EAST ROSWELL LIBRARY
ADDENDUM NO. 03.1-2
APRIL 22, 2013

This Addendum No. 03.1-2 dated April 22, 2013 issued by Ajax Building Corporation of Georgia is hereby made part of Bid Package 03.1 – CONCRETE for the East Roswell Library. The changes and/or clarifications included in this Addendum shall be considered as part of the Bidding Documents and shall supersede, amend, add to, or subtract from those conditions included in the original Bidding Documents, including the Project Bid Package, Drawings, Specifications, previous Addenda, etc. This Addendum must be acknowledged in the space provided on the Proposal Form (included in Section II of the Bid Package). Failure to acknowledge this Addendum may subject Bidder to disqualification.

East Roswell Library

ADDENDUM NUMBER ONE

UTILITY PLAN

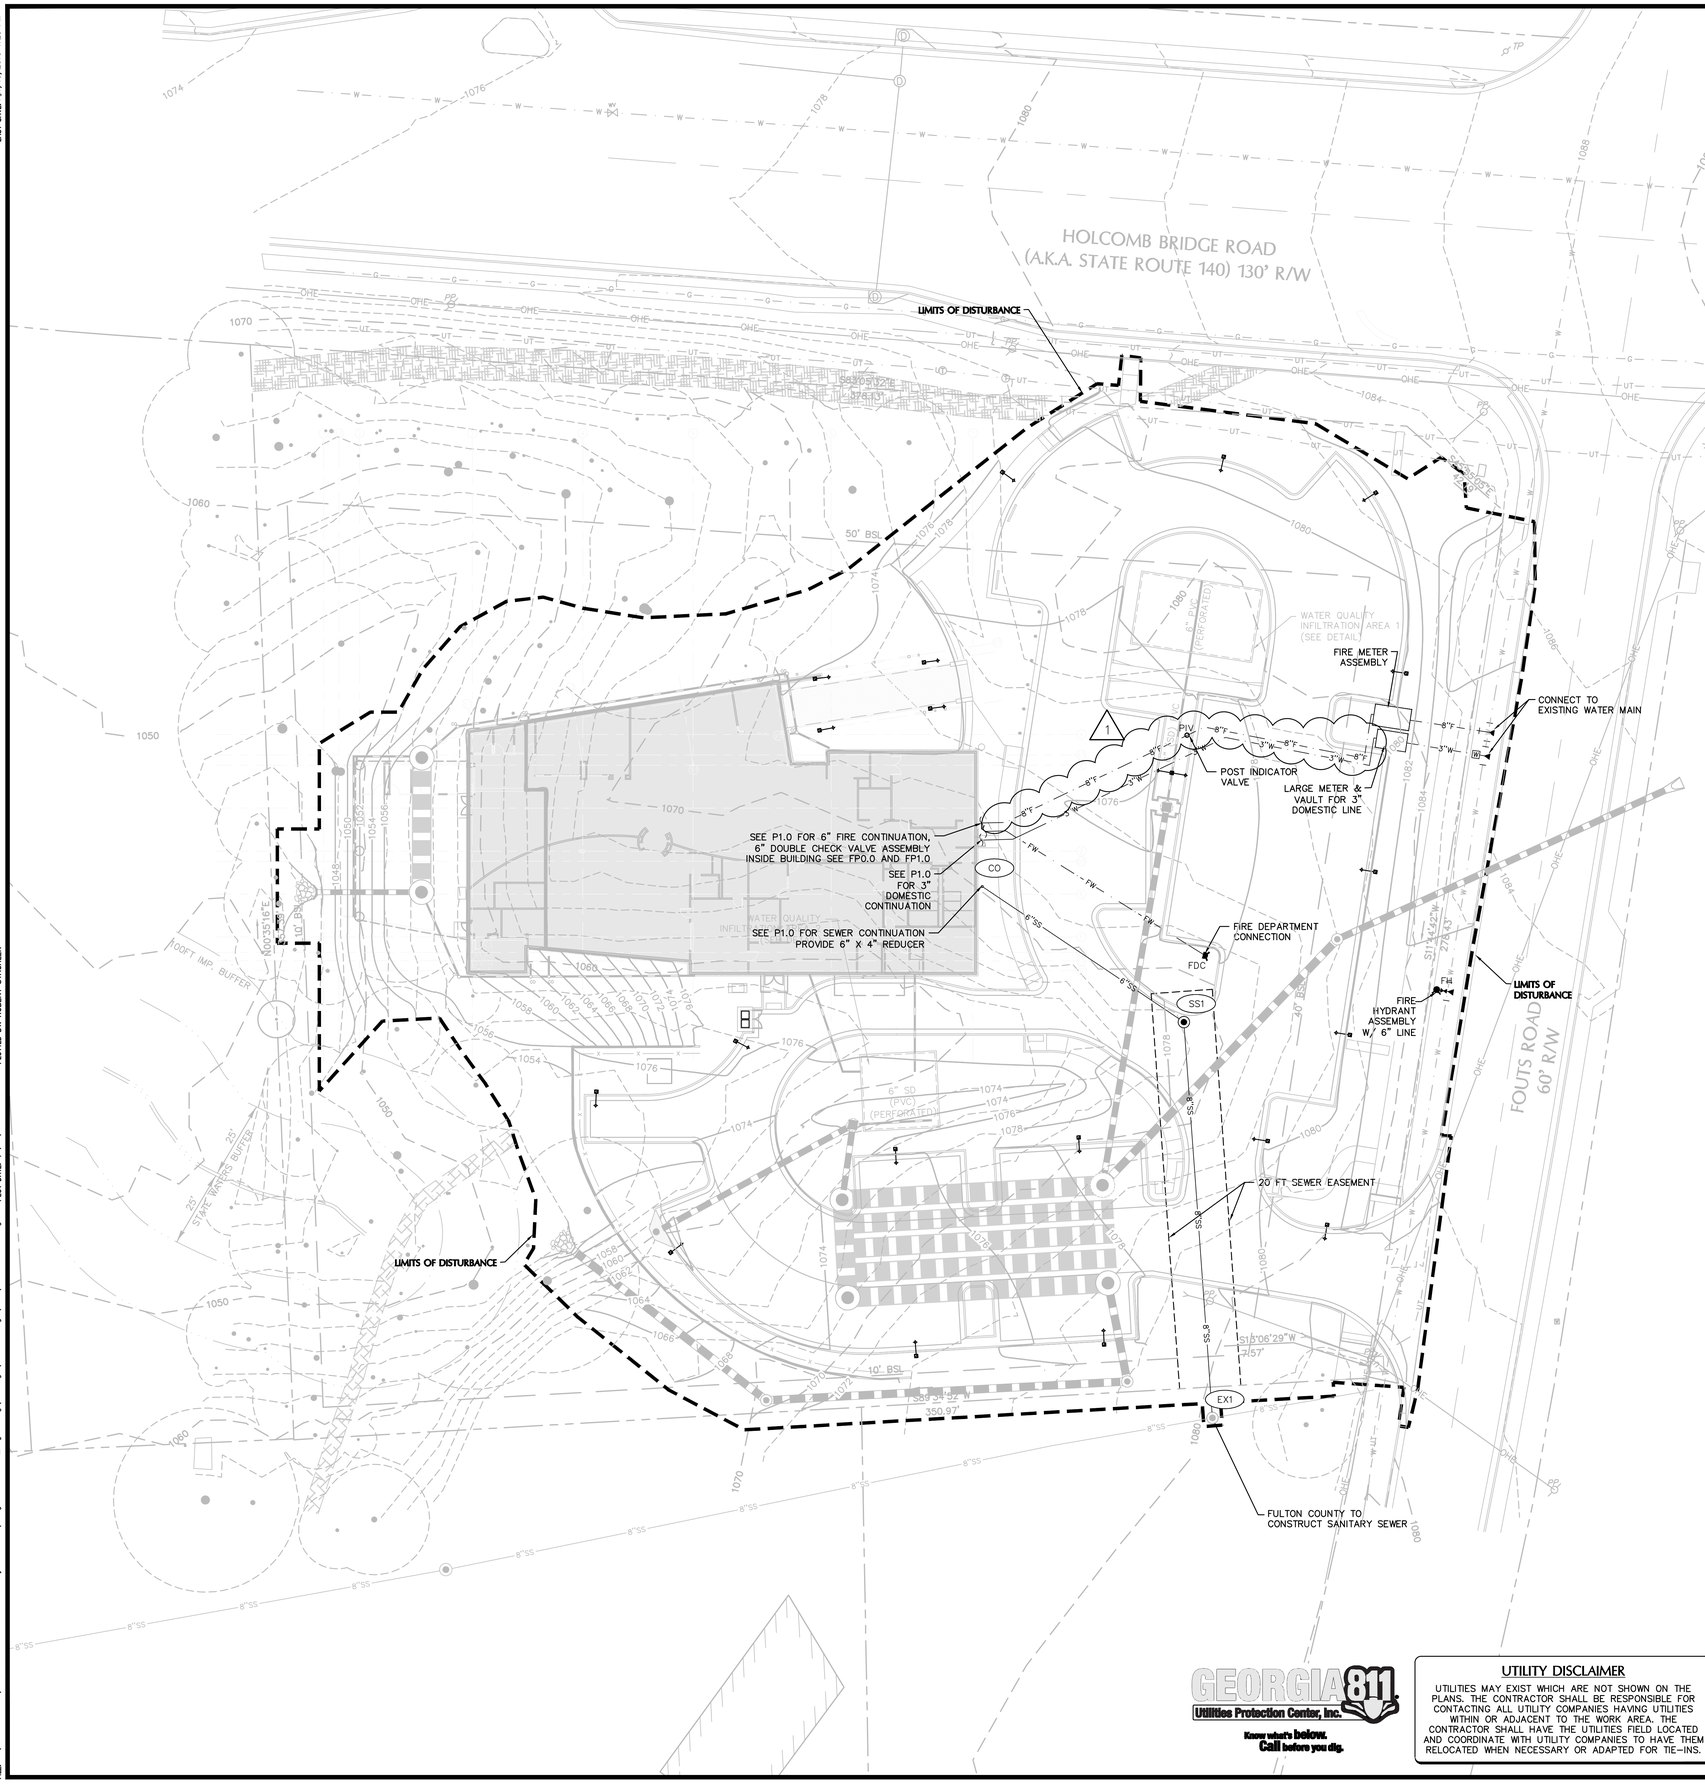
1. The following sheets are issued herewith:
   a. C-500 Utility: delete the sheet and replace with the attached sheet. The fire line between the fire meter assembly and the building has been upsized from a 6-inch line to an 8-inch line.
   b. FP0-0 - Fire Protection Legend, Schedule and Details: delete the sheet and replace with the attached sheet. Detail 4 – Added a 6" tag to the outgoing line on the Double Check Valve Assemblies Detail, DCVA, and changed the incoming fire line size from 6" to 8" on the same detail.

1 BASEMENT FLOOR PLAN - FIRE PROTECTION
1/8" = 1'-0"

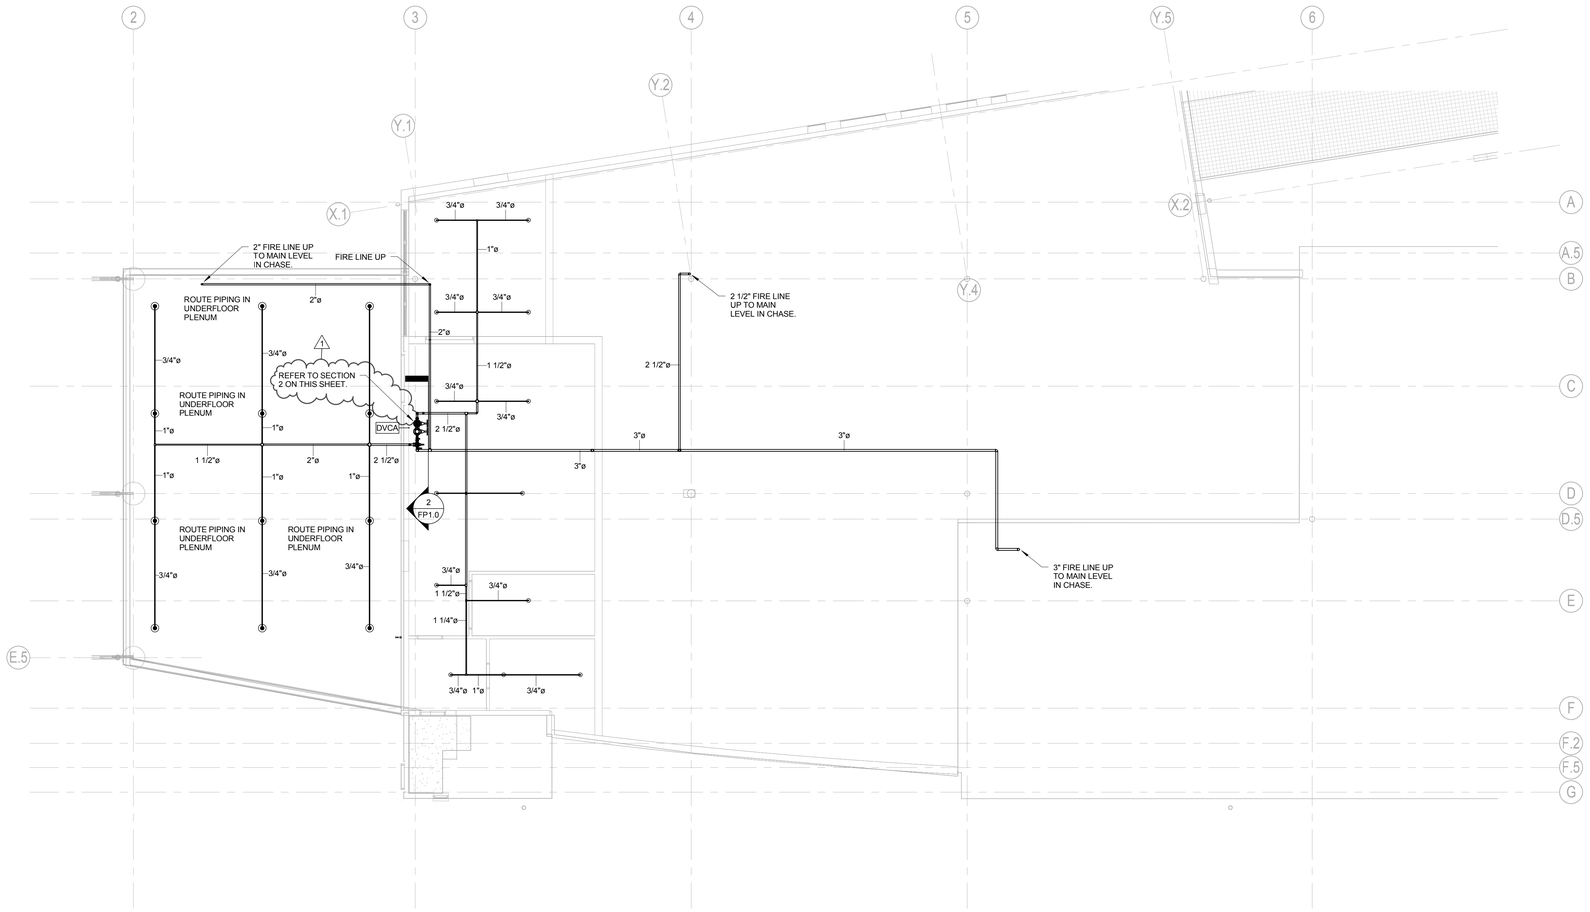
c. FP1-0 - Basement Floor Plan - Fire Protection: delete the sheet and replace with the attached sheet. Plan - Changed the note pointing to the DCVA to read as follows: "Refer to Section 2 This Sheet."
